# TOWN OF DAVIE TOWN COUNCIL AGENDA REPORT

**SUBJECT:** Quasi Judicial Hearing: Variance

V 2-1-01 C. William Laystrom, petitioner/Willow Acquisitions, L.L.C., Owner - 15700 Pointe West Drive/Generally located on the north side of Griffin Road, between Weston Road and I-75.

# TOWN OF DAVIE Development Services Department Planning & Zoning Division Staff Report and Recommendation

Table 20 Properties Rich Gase Honda	-	LANDSCAPE ARCHITECTS COLLABORATIVE 400 Semillature Sensitives (Sensitives) Sensitives (Sensitives) Sensitive (Sensitives) Sensitive (Sensitives) Sensitive (Sensitives)
, [0.6]	20 m	Control Develope Treats Assessment

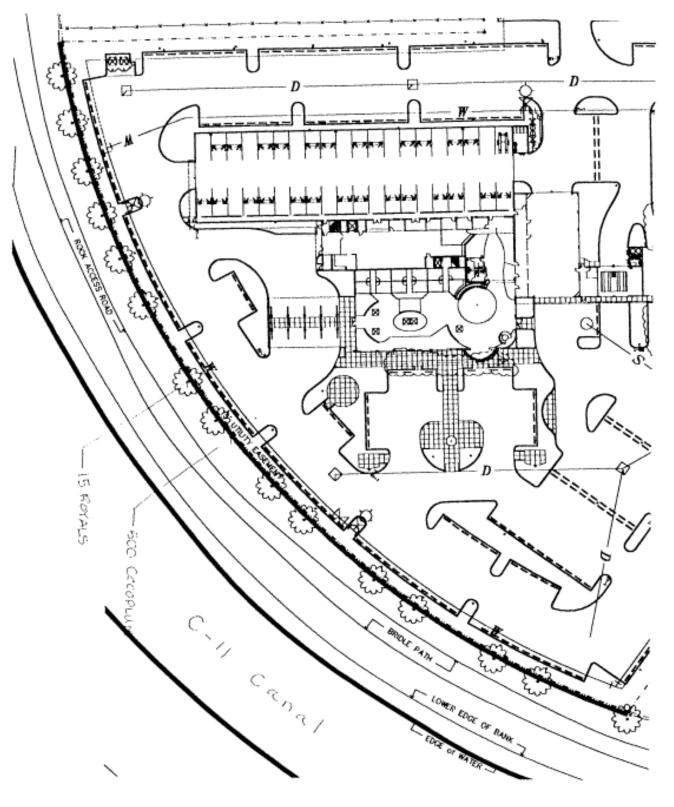
PLANNING AND ZONING BOARD RECOMMENDATION: The Planning and Zoning Board recommended approval of the variance subject to and conditioned upon the applicant providing a covenant running with the land that they would maintain Royal palm trees according to a map exhibit described as L-1-05 project Rick Case Honda Master Landscape Plan, Davie Commerce Center, of which a reduced copy would be provided to the Town Clerk to be marked as an exhibit, and that would consist of no less than 54 Royal palm trees running along the area that was depicted on the map; with a further covenant running with the land that those palm trees would be maintained by the property owner who was seeking the variance; that the petitioner has agreed to submit the approval letter from the South Florida Water Management District; and that the petitioner would work with staff to determine the height of the Royal palm trees. (motion carried: 5-0, March 28, 2001)

<u>PLANNING AND ZONING BOARD RECOMMENDATION</u>: Approval of the revised South Florida Water management District Landscape Plan, subject to all the conditions as approved last time, with the one change being in the number of Royal palms (being 14). (Motion carried 5-0, April 25, 2001).
